# Work Order ID 96759

Item Name: Crosstube Turning DetailL

<b>DART AEROSPACE LTD</b>	<b>Work Order:</b>	96759
<b>Description:</b> Crosstube Assembly (206L High Fwd)	<b>Part Number:</b>	D206-667-143
<b>Inspection Dwg:</b> D206-667-143 Rev: C		<b>Page 1 of 2</b>

DRAWING NO. D206-667-143	TITLE CROSSTUBE ASS'Y (206L HIGH FWD)	REV. C	DART AEROSPACE LTD ENGINEERING ORDER		D.E.O. NO. D206-667-143-C-1	SHEET NO. SHEET 1 OF 1	SCALE NTS
DRAWN 9	CHECKED ASS	MFG. APPR. [Signature]	APPROVED [Signature]	DE APPR. [Signature]			
DATE 11.07.15	DATE 11.07.20	DATE 11.07.21	DATE 11/07/21	DATE 11.07.21

D206-667-143  
ASSEMBLY DETAIL  
(VIEW LOOKING FWD)

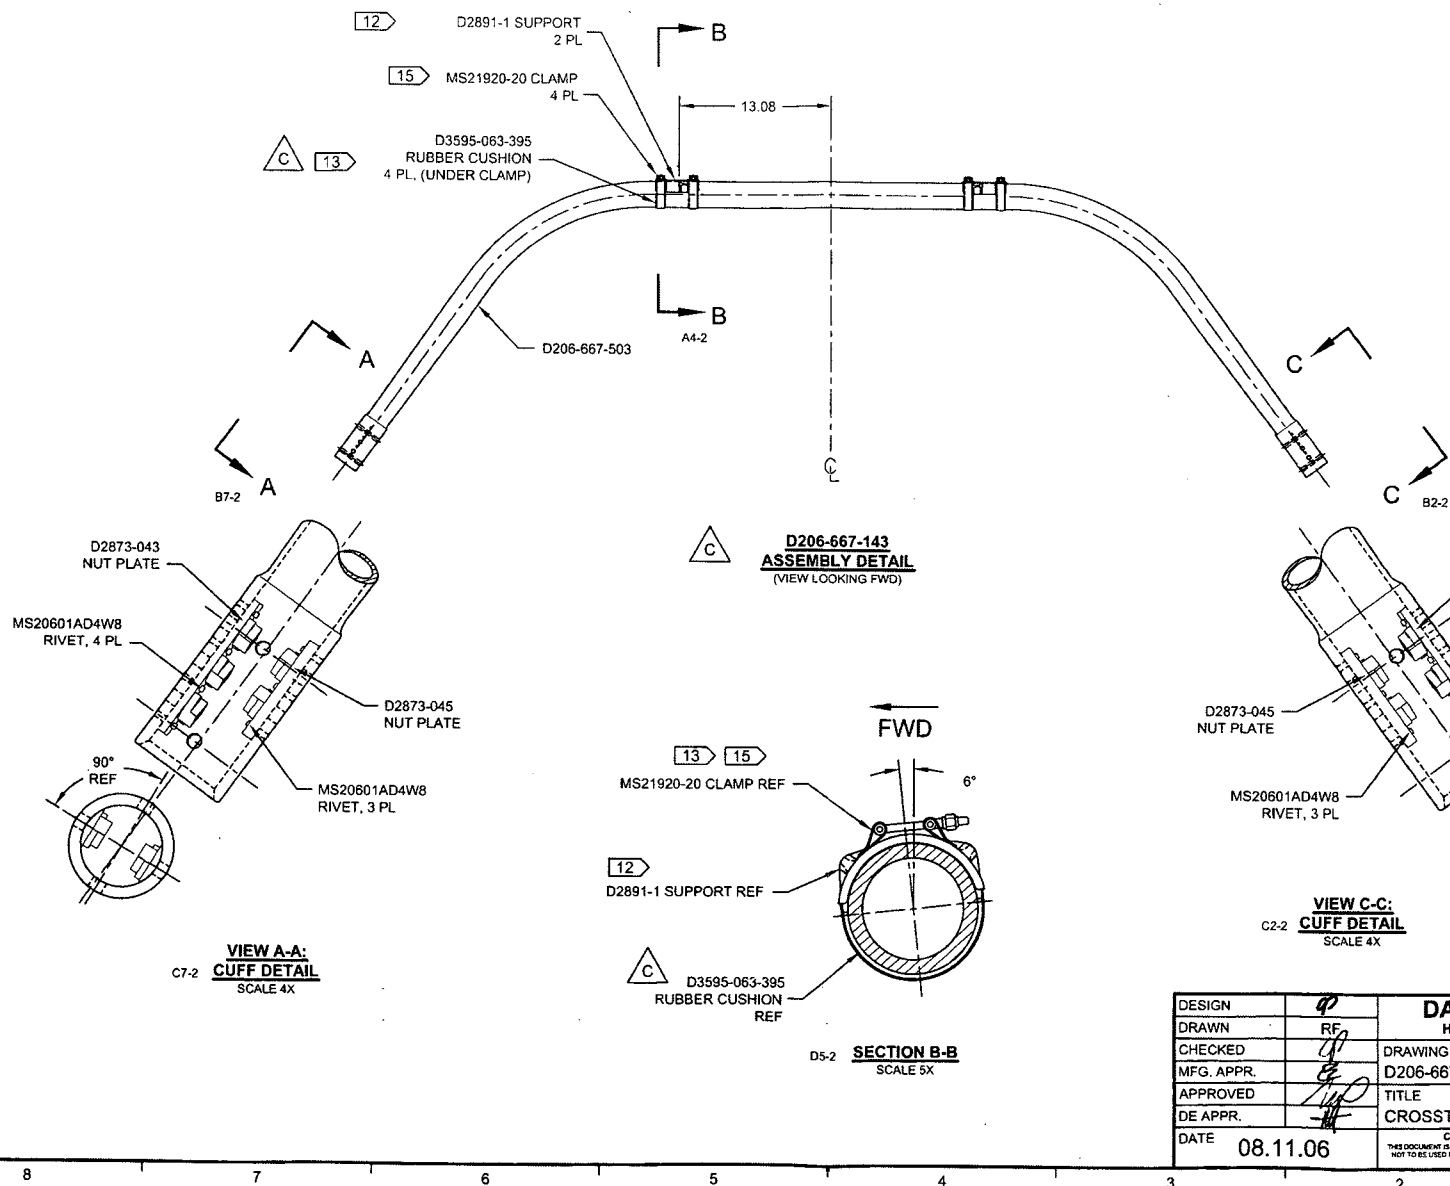
C	REVISE GENERAL NOTES/PART LIST (ZN D7-1); REORGANIZED VIEWS AND REFORMATTED DRAWING TO CURRENT STANDARDS. D3595-063-395 WAS D2856-400-694 (ZN D6-2 & A5-2); REMOVED REF. & ADD TOLERANCE (ZN D3-3, C4-3, C5-3); RELOCATED FLAG #6 (ZN A8-3) PER NCR 210; MOVED TURNING DETAIL & UPDATED TOLERANCE TO SHEET 4.	RF	08.11.06
B	ADD HOLES AND NUT PLATES FOR COMPATABILITY WITH BHT/AA SKUDTUBES	PH	05.07.26
A	NEW ISSUE	CP	00.11.17
REV.	DESCRIPTION	BY	DATE
DESIGN	RF	<b>DART AEROSPACE LTD</b> HAWKESBURY, ONTARIO, CANADA	
DRAWN	RF		
CHECKED	RF	DRAWING NO.	REV. C
MFG. APPR.	RF	D206-667-143	SHEET 1 OF 4
APPROVED	RF	TITLE	SCALE
DE APPR.	RF	CROSSTUBE ASS'Y (206L HIGH FWD)	NTS
DATE	08.11.06	<small>COPYRIGHT © 2000 BY DART AEROSPACE LTD THIS DOCUMENT IS PRIVATE AND CONFIDENTIAL AND IS SUPPLIED ON THE EXPRESS CONDITION THAT IT IS NOT TO BE USED FOR ANY PURPOSE OR COPIED OR REPRODUCED IN ANY FORM OR BY ANY MEANS WITHOUT WRITTEN PERMISSION FROM DART AEROSPACE LTD.</small>
